NO. 15/2018

START SWITCH UPDATE + REMOVAL OF GREASE

Executive summary

Sealing of the parting line

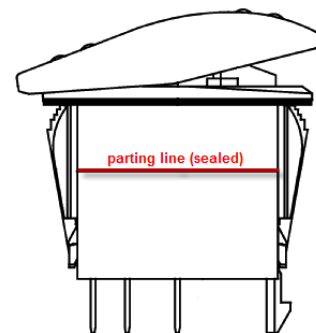
The removal of grease is **only valid for the connector of the starter switch** and does not concern any other connectors of the wiring harness.

This improvement has a minor impact but helps to assure the trouble-free operation of the multiple function switch.

IMPORTANT: The sealing prevents water intrusion.

For this reason, the switch must not be opened!

By opening the switch will break the sealing which can cause failure and warranty becomes void.
